SEWAGE DISPOSAL SYSTEM

MARYLAND STATE DEPARTMENT OF HEALTH DISTRICT

P46121 Repair 2640 McKendree Rd

P _____
A REPAIR

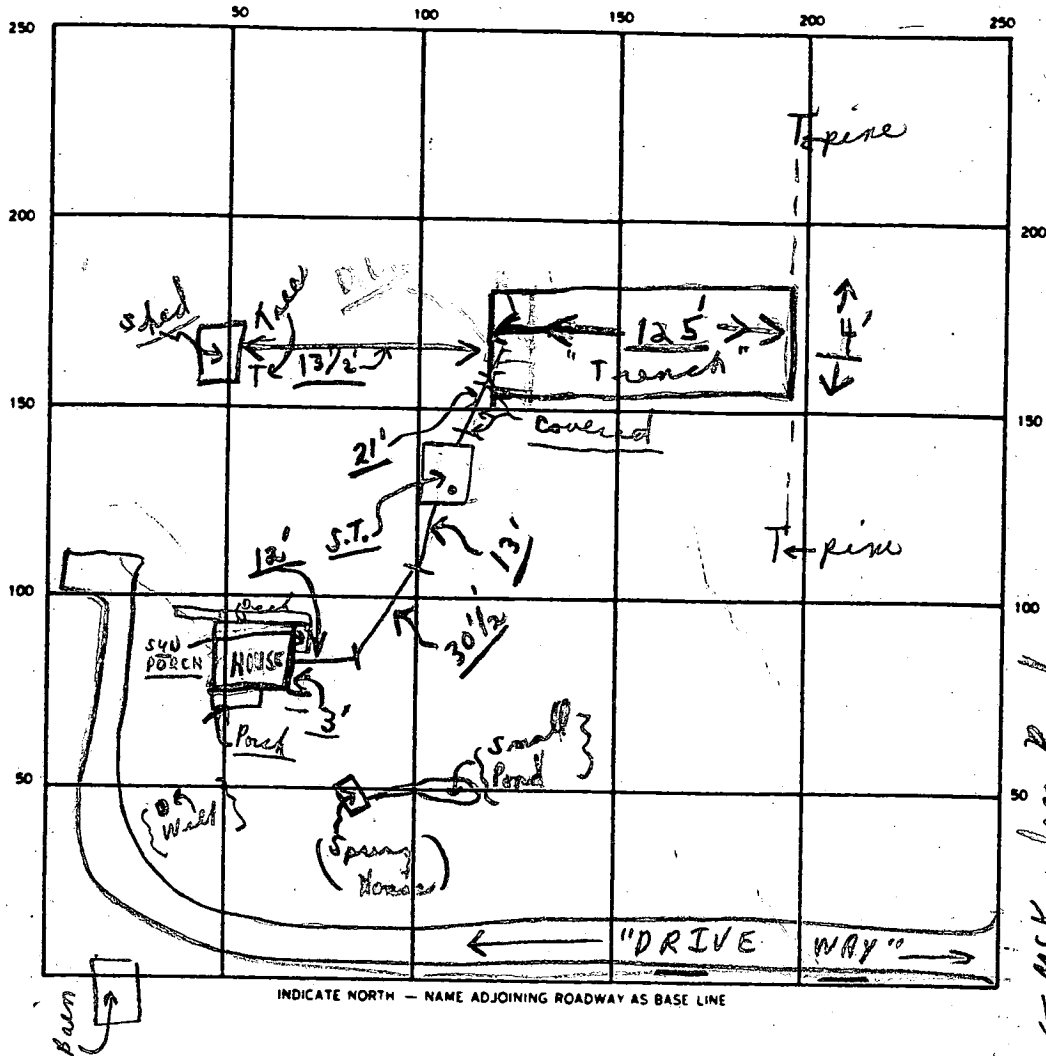
REMARKS 5/18/90 Partial - ok to cover from house to trench; ok for stones in trench only; first 50' of trench ready; c.B.S. 5/18/90 late p.m. - ok to cover as finish. File - Final.

P 46121 Repair

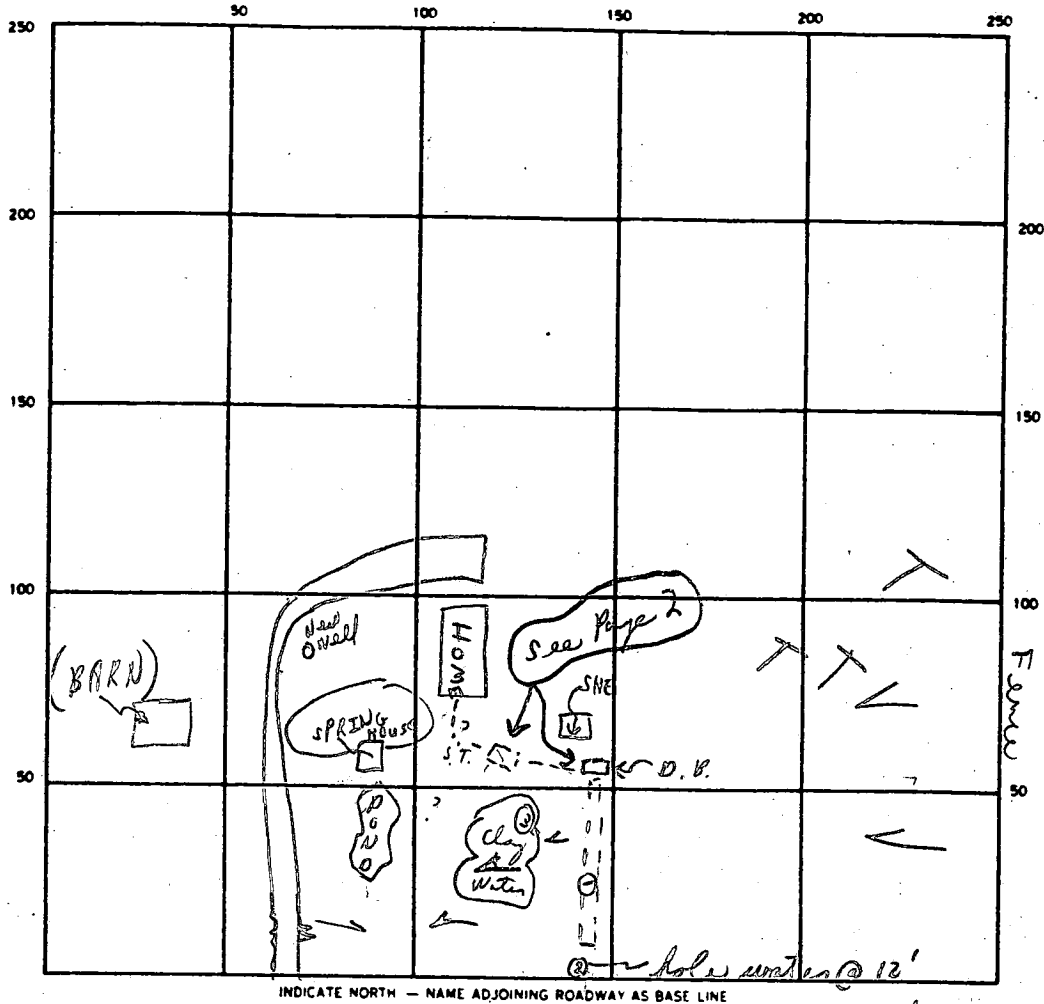
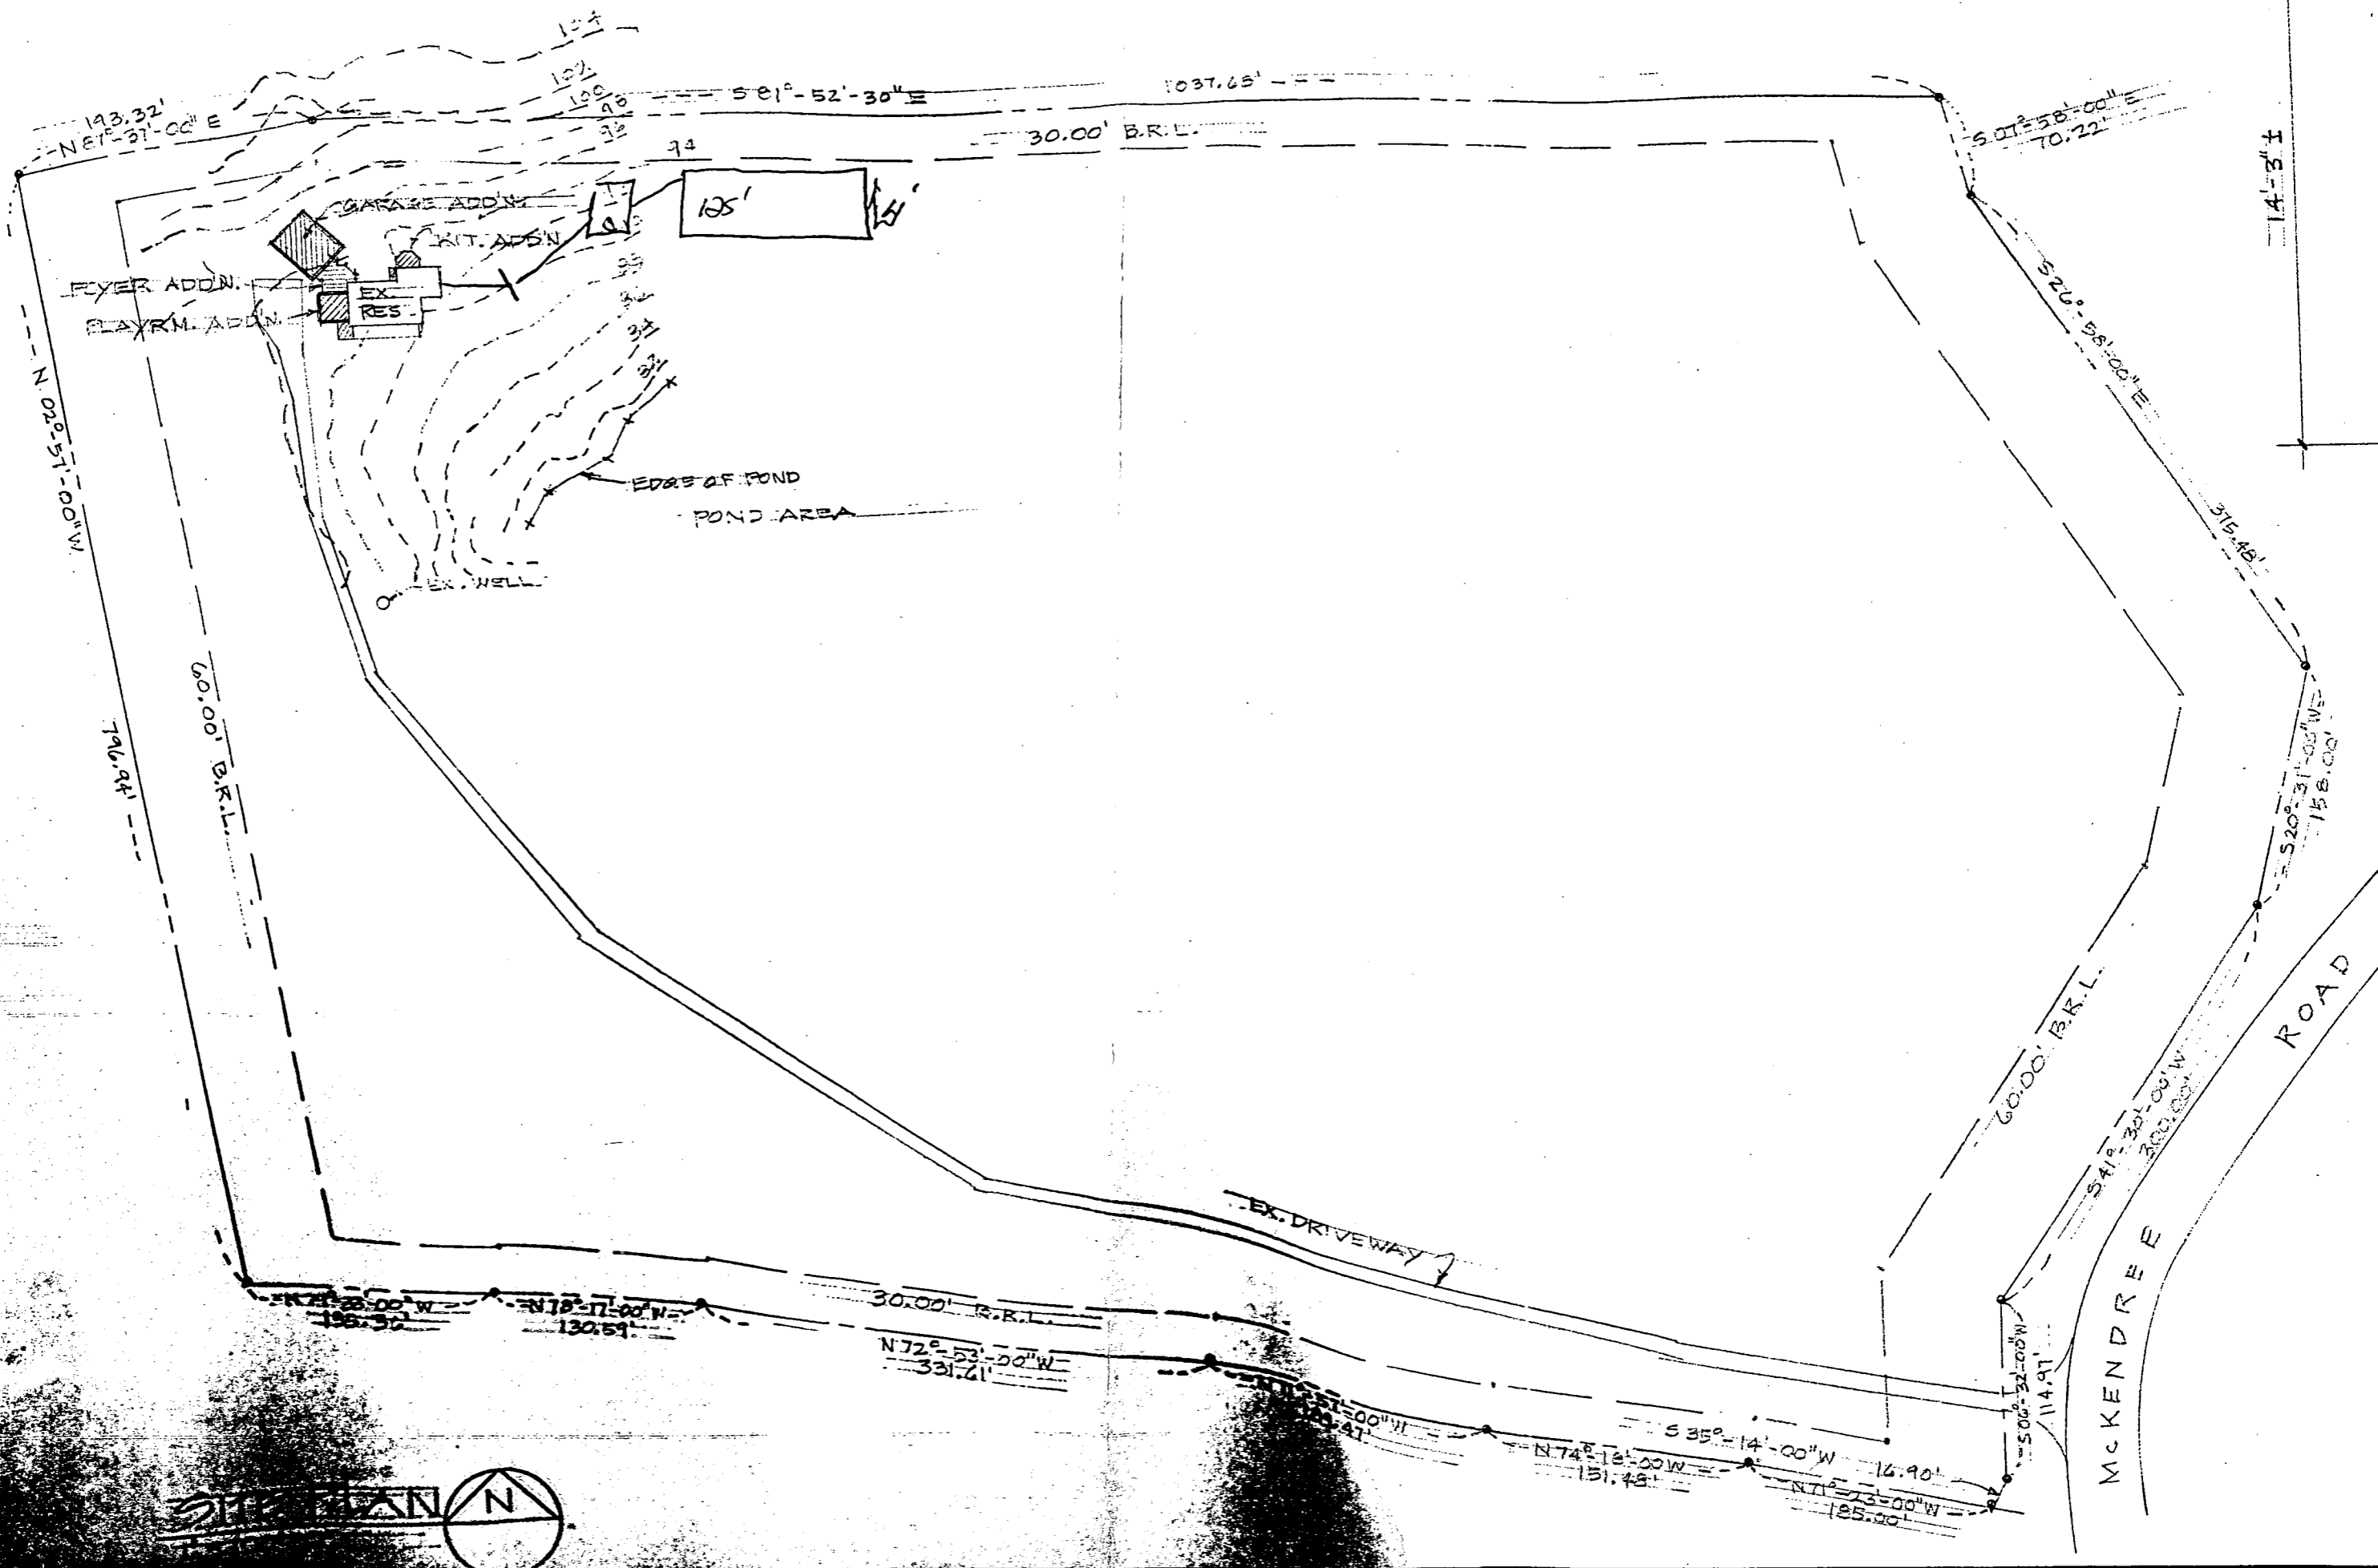
Need (?) in line C.O. may be needed

REMARKS partial - 3/14/90 locate trench near "D" hole on high
area of lot. Note: * existing house + plumber to
put system in the hill without a pump, away from
ground w/ high water table; ok to continue C.B.D.
(C) 5/18 see page 2.
= C.B.D

30' to 40' off fence - to rear of house
4' wide - 125' long 1 trench 4' hill
depth shallow as can be - (8' to 9')
1 1/2' of stone under pipe, pipe near center
(trench) pit both at start of trench. C.B.D.

GARAGE
ADD'N

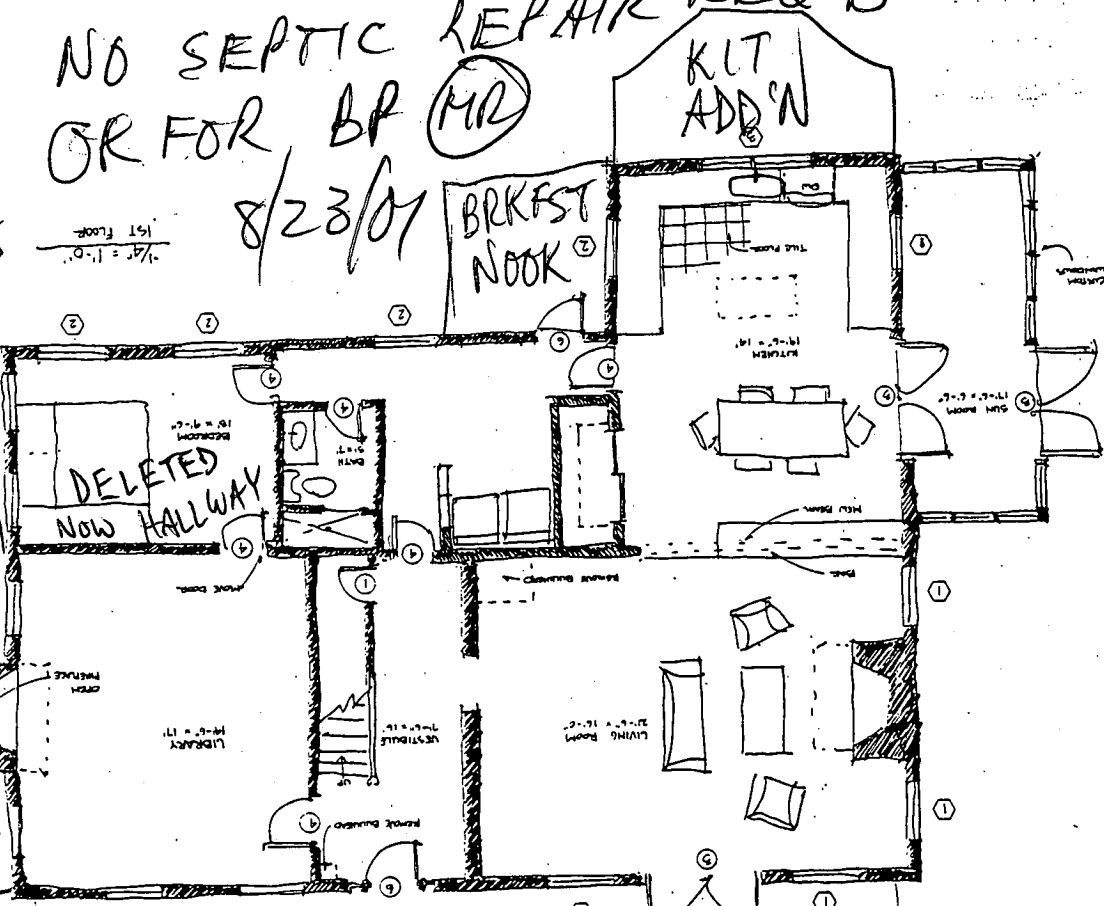
1 BR ADDED, 1 BR DELETED

NO SEPTIC REPAIR REQ'D

W/O FIRE
EGRESS
WINDOWS
(NOT A
BR)
